# SERVICE BULLETIN

## ROTOR DISC CHANGE COUNTER (P/N 166-33200) FOR THE 30-191 BRAKE ASSEMBLY

SB7109  
Page 1 of 4

Figure 1  
Install the nameplate

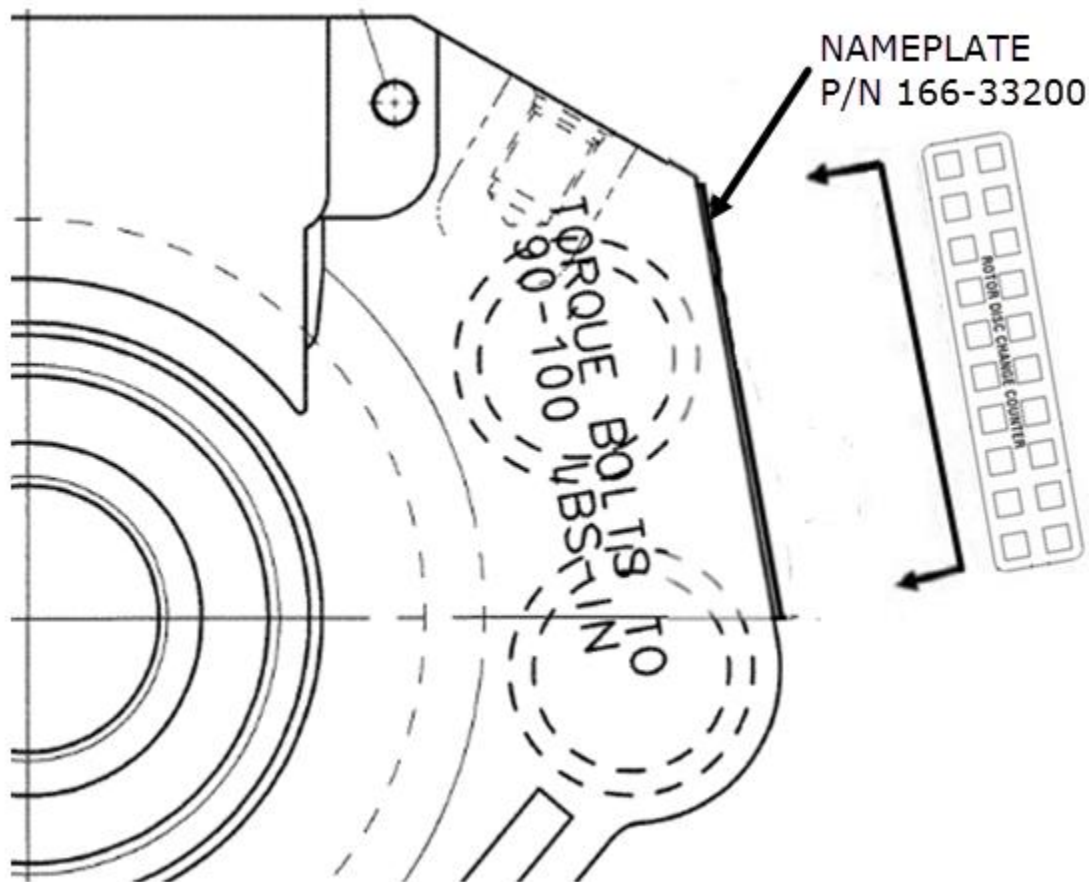
P/N 166-33200 depicts boxes which are to be permanently marked every time the rotor disc (P/N 159-02700) is replaced at overhaul (See Figure 1). Thus, keeping a record of the number of rotor disc changes associated with the brake assembly.

1. Adhere double stick tape (219-05800) to back of nameplate
2. Trim tape in the form of the nameplate.
3. Adhere nameplate to the cylinder housing (061-13000) as shown in Figure 2. No overhang of the nameplate with respect to the cylinder housing is permitted.

Whenever a rotor disc (159-02700) is replaced, permanently mark one box on the 166-33200 nameplate in sequence.
